Revised Road Safety Audit Stage 2

Millfields Farm, Rusper S278 Works

Project Name:	Millfields Farm, Rusper S278 Works
Project Number:	SRSS-109
Report Title:	Revised Road Safety Audit Stage 2
Report Number:	Report SRSS/2026/109

Photograph 2 shows East Road looking west towards new development access on Left and proposed gateway signage

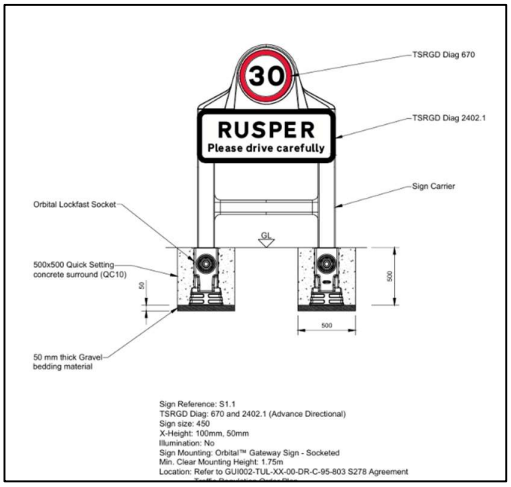
Whilst it is acknowledged that the speed limit is being extended to beyond the junction to the development. The proposed speed limit sign will be incorporated with a framework which will also facilitate the village name and will be 'passively' safe. The audit team were concerned that the verge width may not fully accommodate the sign assembly and leave the minimum 450mm clearance to the edge of the carriageway.

In addition the speed limit sign face is shown as being 450mm which is too small to be considered a terminal sign and may lead to difficulties in respect of future enforcement of the speed limit sign.

If the sign assembly cannot be full accommodated within the verge that the speed limit be further extended to a location beyond the property known as Thatched Barn. This may enable the gateway feature to be installed on both the nearside and offside verge to create a full gateway feature

A terminal speed limit sign also be placed at this location which would then enable gateway feature and signage to enhance and supplement the speed terminal sign.

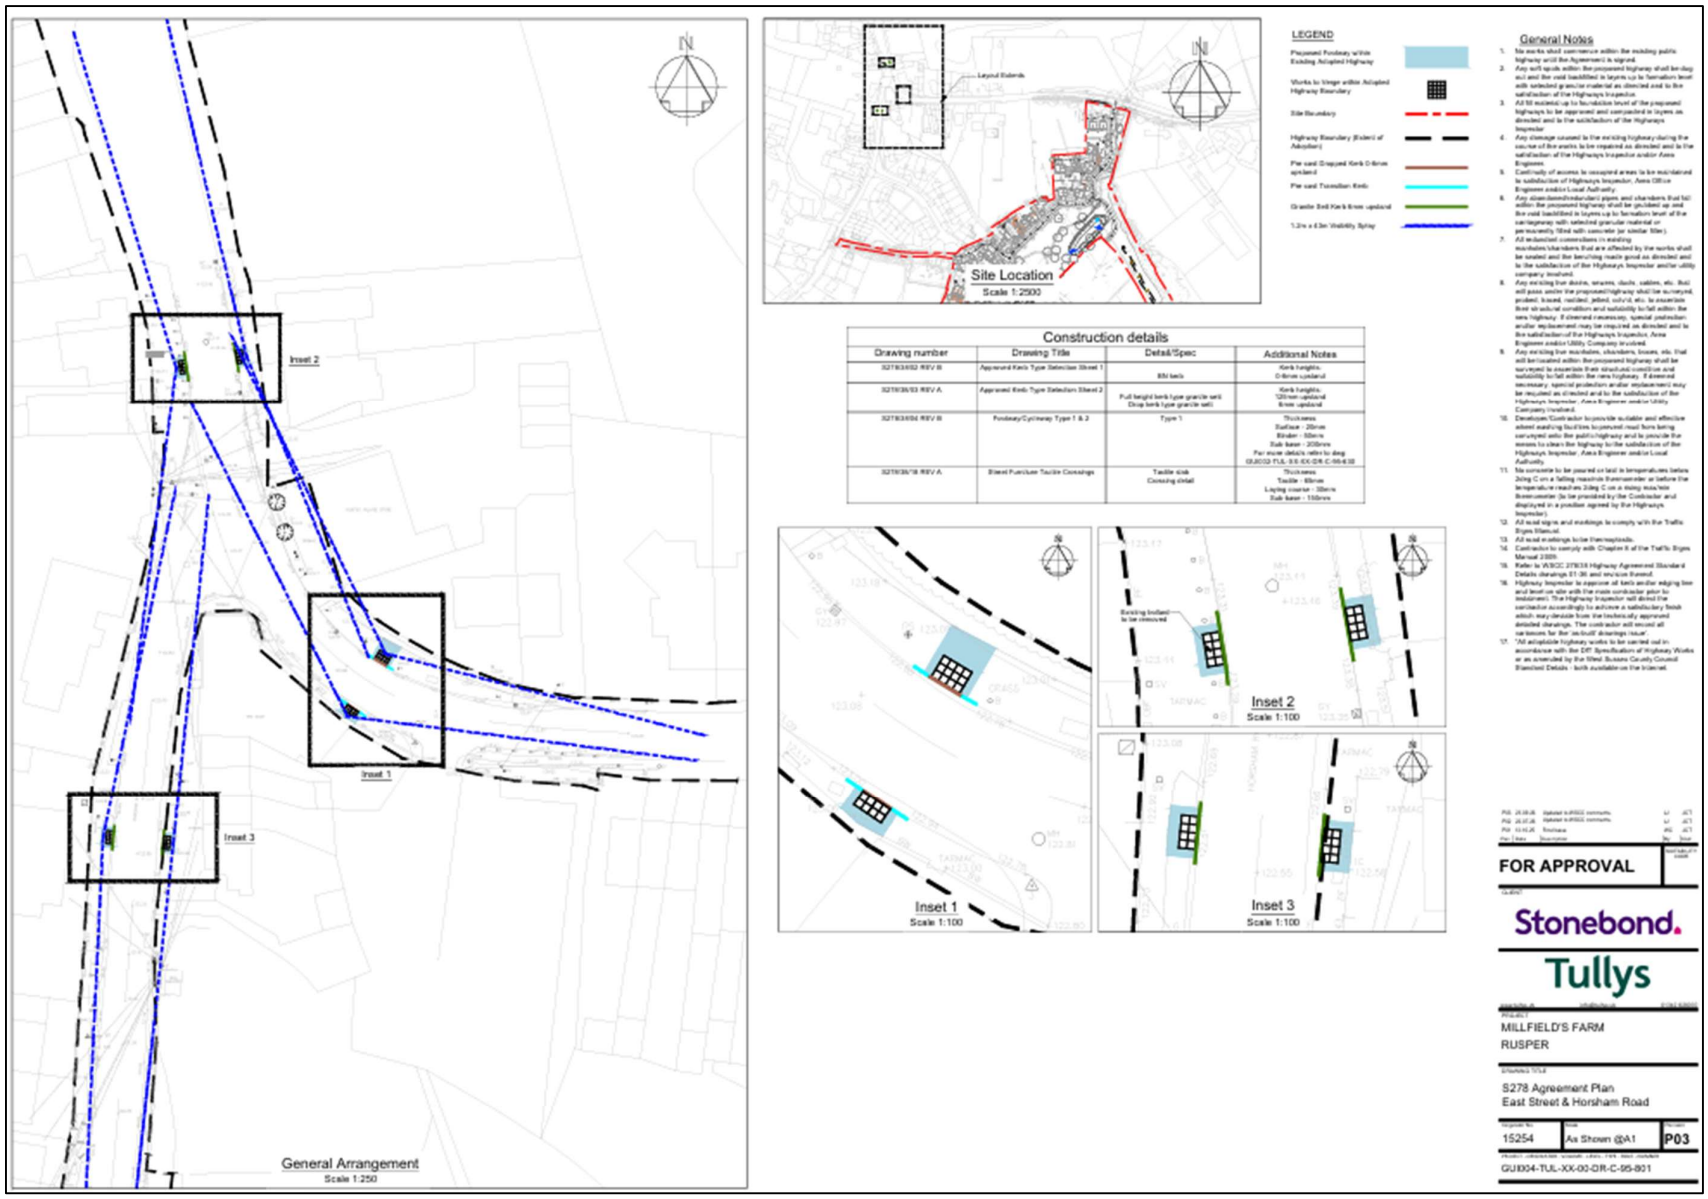
Summary: Risk of vehicle /Pedestrian conflicts from increased vehicular traffic

An existing footway (1501) is situated adjacent to the new access currently under construction. Any pedestrian accessing East Street from this public footpath will be required to walk in the carriageway where there is no footway or street lighting proposed. (This is likely to be further exacerbated with the additional development proposed by Devine Homes located further west along East Street.)

Although the speed limit is to be extended pedestrians on East Street would be left vulnerable to passing/turning traffic, particularly during the hours of darkness where they may be at risk of being struck.

Summary: Lack of Inter-visibility may result in side impact collisions

Although some site clearance has been undertaken to create the junction access into the site, the inter-visibility splay to the left for vehicles exiting the site is still restricted by some vegetation. This is compounded by the fact that the proposed changes to the speed limit have not yet been implemented. This means that traffic approaching the new access have little or no appreciation of the newly formed junction and the likelihood of turning traffic. This could result in side impact collisions particularly with slower heavy construction traffic accessing and egressing the site.

It is recommended that "pedestrian in carriageway" signs to TSRGD diagram 544.1 are situated to the East of the junction to the Millfield Farm development, to warn motorists of the likelihood that they may encounter pedestrians in the carriageway.

It is recommended that appropriate vegetation clearance is undertaken to increase the conspicuity of the new junction.
